November 20, 2009  
NRC3-09-0035

Subject: Detroit Edison Company Response to NRC Request for Additional Information  
Letters No. 14 & 15

Attachments: 1) Response to RAI Letter No. 14 (Question No. 14.03.02-1)  
2) Response to RAI Letter No. 15 (Question No. 02.04.02-3)  
3) Response to RAI Letter No. 15 (Question No. 02.04.13-8)  
4) Response to RAI Letter No. 15 (Question No. 02.04.05-2)  
5) Response to RAI Letter No. 15 (Question No. 02.04.05-3)  
6) Response to RAI Letter No. 15 (Question No. 02.04.05-4)

FIGURE 1  
EXISTING DRAINAGE BASINS  
ASSUMING ALL DRAINS CLOGGED

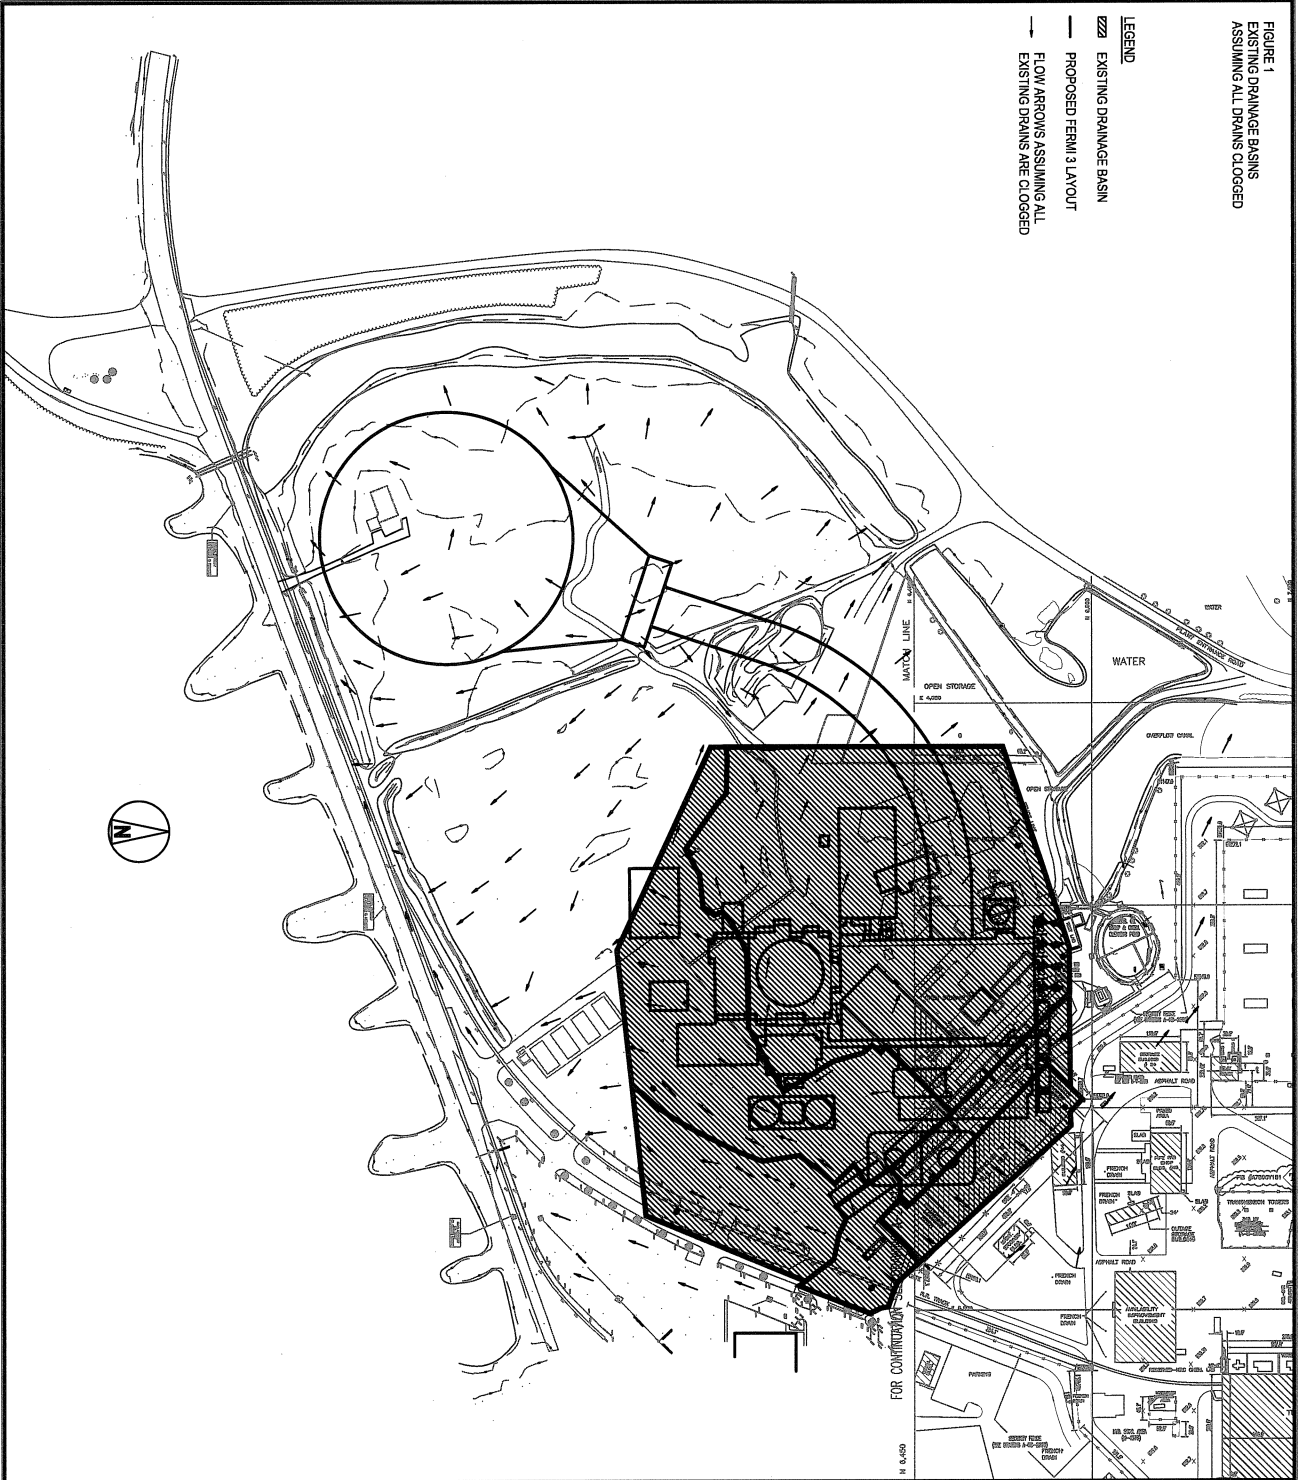
*To meet the requirements of GDC 2 and 10 CFR 52.79(a)(31), and to support the staff's review of the application, information concerning the construction impacts from the Fermi 3 site should be discussed and evaluated. Please provide an evaluation of impacts of surface runoff from Unit 3 to Unit 2 under a worst case scenario (PMP and all storm drains blocked in Fermi 3), incorporating the slopes and other relevant factors of potentially downgradient land in the vicinity of both units. Provide an illustration of the routes taken by runoff in the vicinity of Units 2 and 3 during the worst case scenario. Describe the function of the French Drains northeast of the proposed nuclear island for Unit 3 and if any flow contribution is being accounted for in the flooding scenario.*

Figure 1 (attached) shows the proposed Fermi 3 layout superimposed on the existing drainage basin. As shown in Figure 1, the proposed Fermi 3 elevated area could result in increased area for runoff to flow towards Fermi 2 as compared to the existing site topography. This excess area for runoff is shown more specifically on Figure 2 (attached). Figure 2 was developed by overlaying the existing drainage basins from Figure 1 with the final grade drainage basins from FSAR figure 2.4-2 15. The excess area flowing towards Fermi 2 is the area that drains elsewhere during existing conditions, but will flow toward Fermi 2 under developed conditions. The excess drainage area that could drain towards Fermi 2 is approximately 1.18 acres.

In addition to showing the proposed Fermi 3 layout superimposed on the existing drainage basin, Figure 1 also shows the runoff flow patterns as the water enters the Fermi 2 area from the northeast side of the Fermi 3 elevated area. As the water enters the Fermi 2 area, the runoff will follow the drainage pattern, as depicted by the flow arrows on Figure 1, to the existing roads northwest until it reaches the northern lagoon where it continues flowing north to Swan Creek. This flow pattern is away from the Fermi 2 safety related structures.

FIGURE 3  
COOLING TOWER BASINS

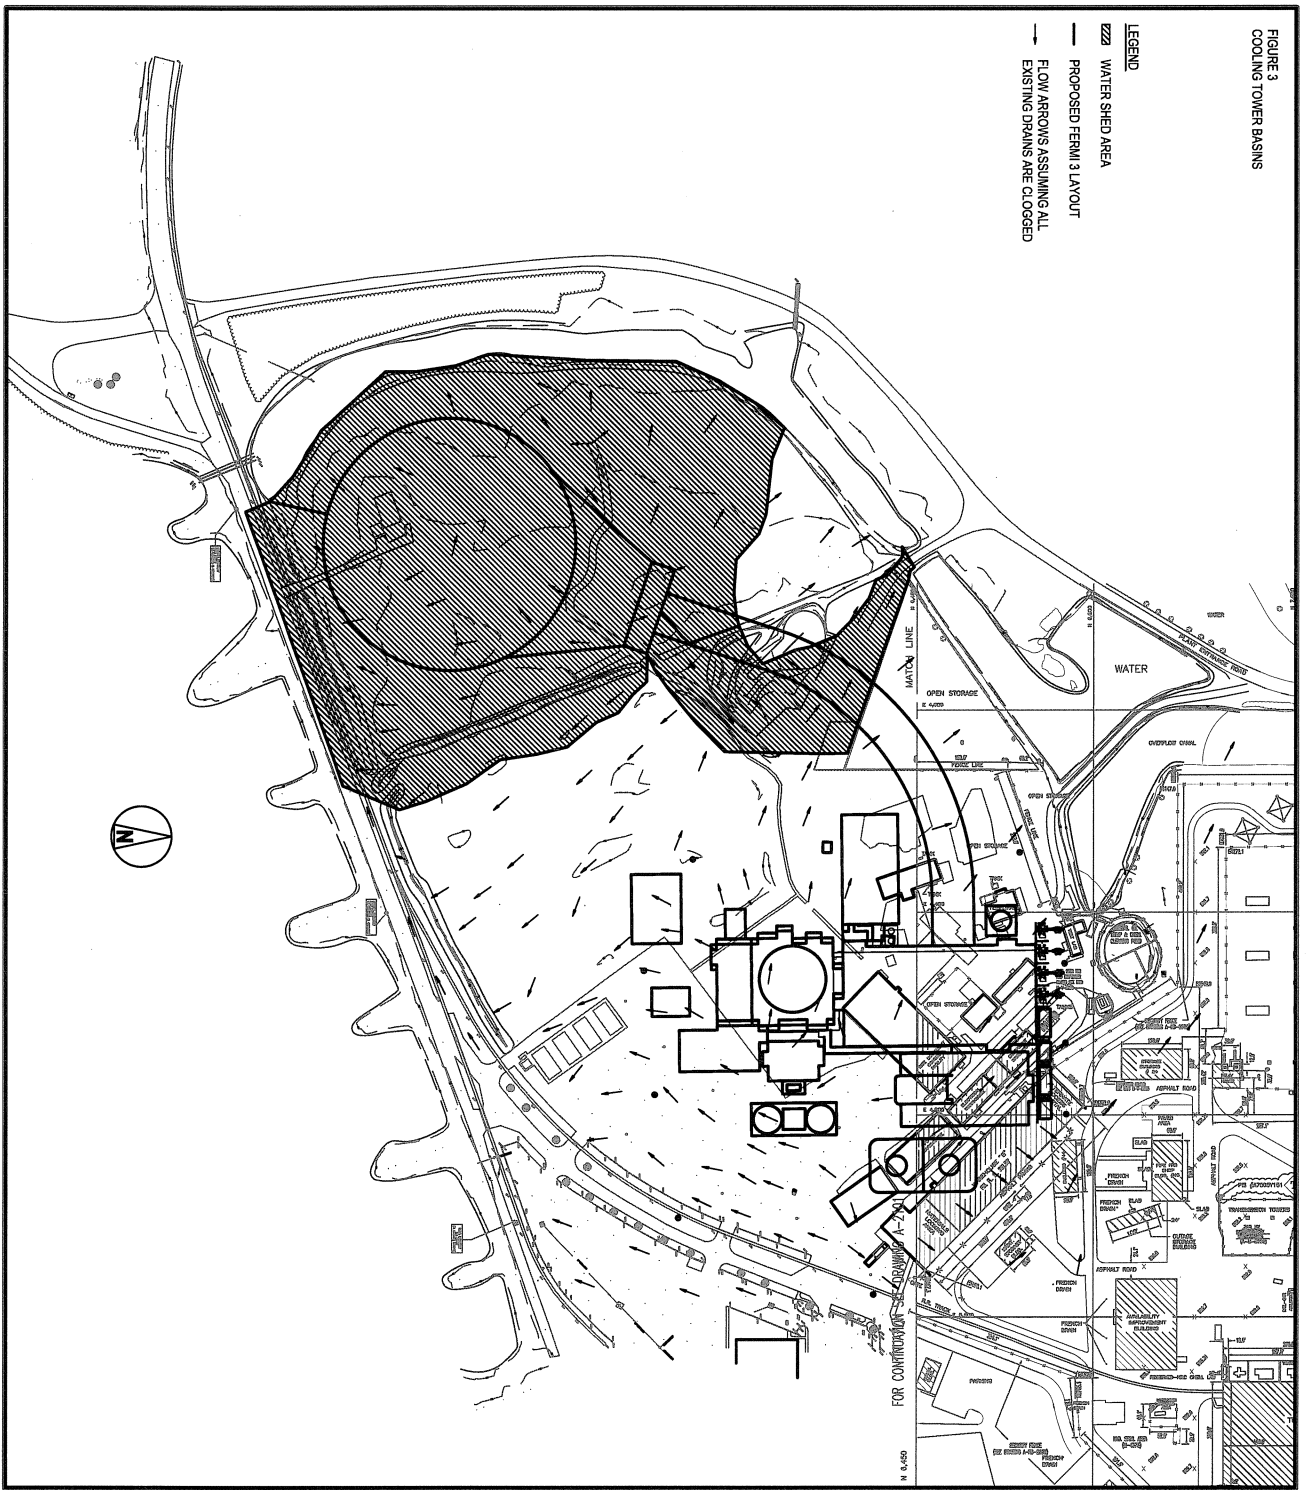
*Additional details regarding Fermi 3 site grading and drainage systems to ensure that the discharge water due to a failure of the tower or the CWS piping does not effect the safety-related systems or equipment that are located in the SC I and SC II structures.*

Figure 3 (attached) shows the flow paths in the yard and the vicinity of the NDCT based on the slope of existing grading. Proposed grading in this area will follow the existing grading to the extent practical as shown on Figure 3. The yard area east and south of the NDCT slopes to the south, and the yard area west and north of the NDCT slope to the west. The Fermi 3 power block area is elevated to 589.3 NAVD 88 as indicated in FSAR Section 2.4.10 which is above the elevation west of the NDCT, south lagoon area, and north area leading to the north lagoon. Water discharged from the postulated break in the CIRC line above grade would initially flow west away from Fermi 3. If the water began to pool, water would flow north and south to the north and south lagoons. Therefore, safety-related SSCs would not be subjected to flooding as a result of a failure of the largest NDCT component.

**Figure 1.  
Transect Used in Bretschneider Method**

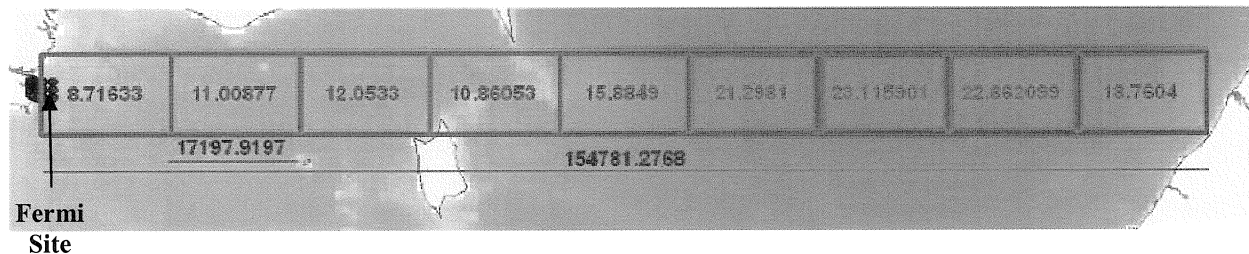
*To meet the requirements of GDC 2, 10 CFR 52.17, and 10 CFR Part 100, and to support the staff's review of the application, estimates of the probable maximum storm surge are needed. Please provide a plan-view figure detailing the spatially distributed results of the STWAVE simulation from which the storm surge height of 3.14 m (10.3 ft) was derived. On the new figure, please note the locations of Fermi 3 and the point/model cell chosen to determine the storm surge height presented in the text.*

Storm surge was not calculated using the STWAVE model. The STWAVE model was used to calculate wave heights in Lake Erie associated with 100 mph winds. The Bretschneider method was used to calculate storm surge (FSAR Ref 2.4-257). Using this method storm surge or wind setup is a function of wind speed, fetch and water depth. The Bretschneider method includes a procedure to account for an irregular lake bottom, which was used in the analysis. The Bretschneider method uses straight line fetches across an enclosed water body. A transect that represented the longest straight line across the lake that ended at the Fermi site was used in the analysis. It was assumed that the calculated storm surge applied to all points along the shoreline at the Fermi site.

Figure 1 below indicates the straight line transect used in the calculations and the depths for each segment. The Fermi site is depicted on Figure 1, depths are the average value in feet above the 100 year lake level.

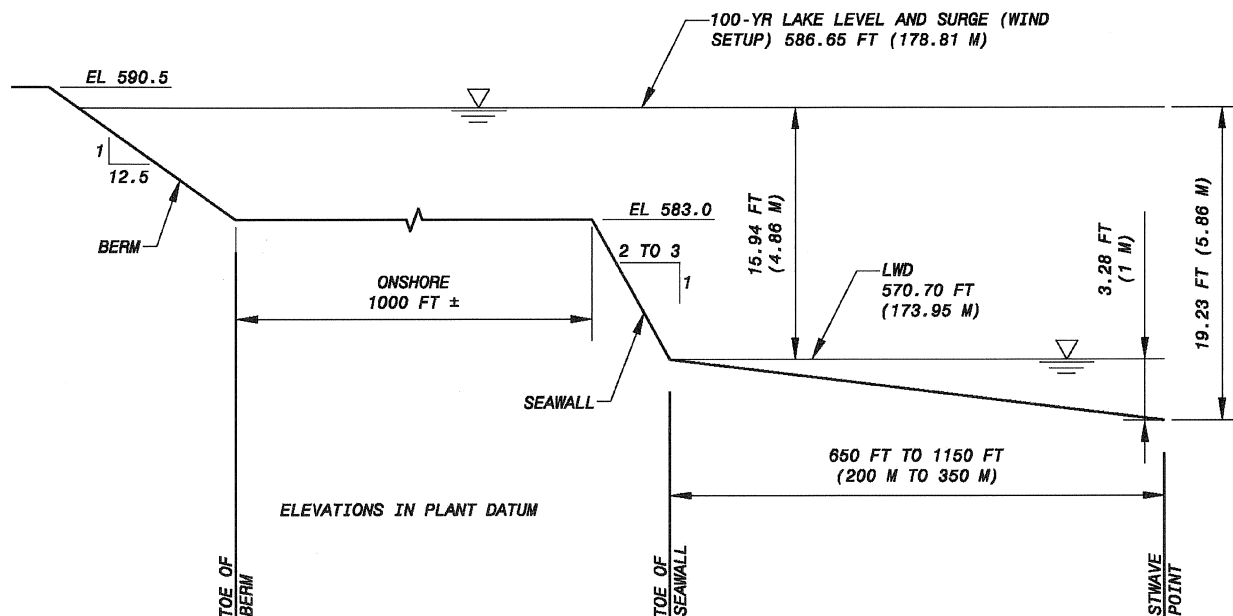
*(1) Please provide a quantitative basis for the following statement in section 2.4.5.3.2.4 "The analysis of wave run-up determined that waves could not directly impact Fermi 3." Describe the elevation at which waves will break along the entire Fermi site when coincidental with a storm surge and independently thereof.*

The following figure presents a cross section showing a transect between the Fermi 3 site to the grid point. Ground elevations and the still water surface water elevation are shown using the Fermi Plant Datum (PD). The water depths are from Mean Low Water (MLW). The areas shown on the figure can be described as:

- Nearshore – the area from 3.3 ft depth (MLW) to 0 ft depth (MLW). This area is between the points used to describe the waves at the shore (from STWAVE model) to the base of the seawall. The area is about 650 ft (200 m) to 1,150 ft (350 m) wide with a slope of about 200H: 1V.
- Seawall – the area of onshore protection from an elevation of 570.7 ft (173.95 m) to 583 ft (177.7 m) with a slope of 3H: 1V to 2H: 1V.
- Onshore - the area immediately behind the seawall. This area is approximately flat with a width of about 1,000 ft.
- Berm – area between the onshore flat area and the project site. This area has a slope of about 12.5H:1V with smooth slopes. Although there is a flat area within this area it ends at an elevation of 590.5 ft.

Wave runup was calculated to be 3.01 ft. This height in addition to the still water elevation of 586.65 (PD) means runup would reach an elevation of 589.66 ft (PD) about 1 ft below the elevation of Fermi 3. The wave runup number calculated by ACES is for the significant wave. The significant wave can be defined as the average of the one-third highest waves. Therefore, the runup value does not consider the effects of larger waves that could be present at the site. To account for the larger waves that could be present at the site an overtopping analysis was conducted. At the elevation of 590.5 (PD), which is the ground elevation of the safety features for Fermi 3, the overtopping rate would be less than 0.004 ft<sup>3</sup>/lineal ft. This amount represents the amount of water that may splash onto the site from an occasional larger wave.

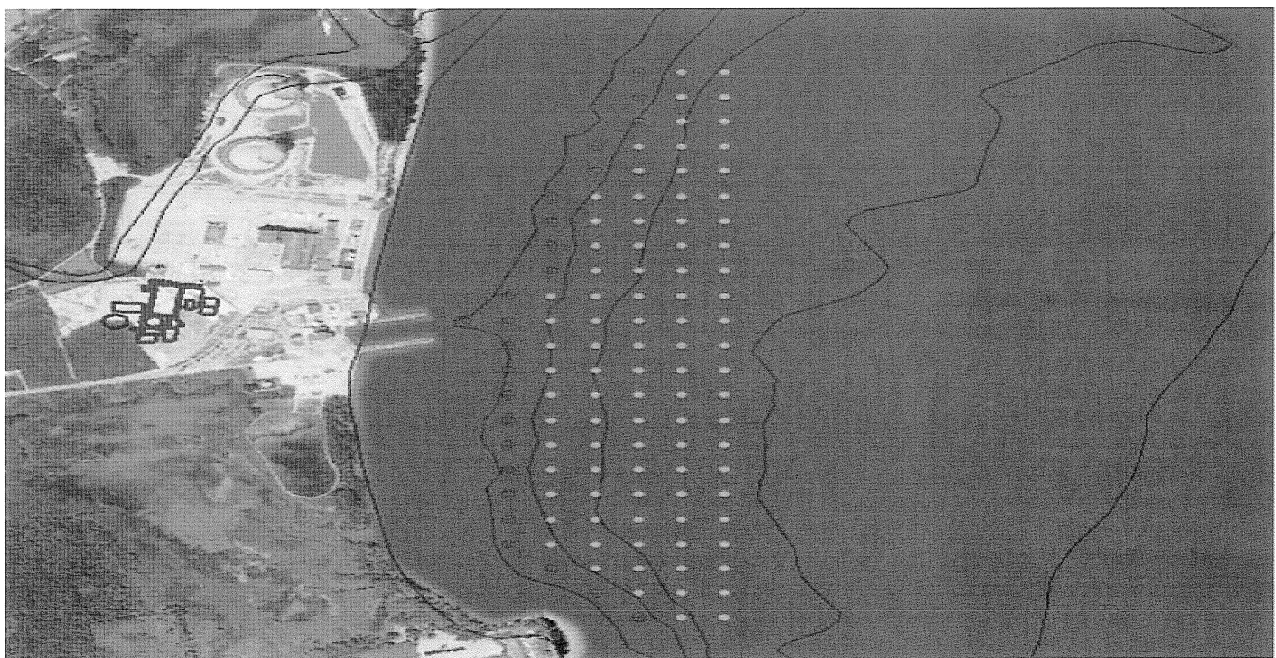
*(2) Please provide a plan-view figure detailing the spatially distributed results of the STWAVE simulation from which the wave height of 3.92 (12.86 ft) was derived. On the figure, note the locations of Fermi 3 and the points that were chosen to determine the highest waves generated.*

STWAVE modeling was conducted for the entire area of Lake Erie using a 100 m grid. The figure below shows the STWAVE grid points in the vicinity of the Fermi site. The red points represent the grid points that are closest to the shoreline in the Fermi area. STWAVE results for these locations were extracted from the model results. The attached table lists the x-y coordinates of the red points and the wave height and period at those locations. Data corresponding to the green points are not shown on the table because they are farther from shore. The green points are shown to indicate the scale of the grid used in the calculations.

The point closest to the shore (Object ID 24) does not have the highest wave height and was not used in the analysis. In order to be conservative, Object ID 11 (fourth red dot from the top of the fifth line from the right) with a wave height of 3.77 m and wave period of 11.1 sec was used in the analysis. There is only one other point (Object ID 3) with a higher wave height. However, a wave at Object ID 3 would move through Object ID 5 location as the wave moved toward the Fermi 3 site. The wave height at Object ID 5 is 3.64 meters. Therefore, using the wave height at Object ID 11 is conservative.
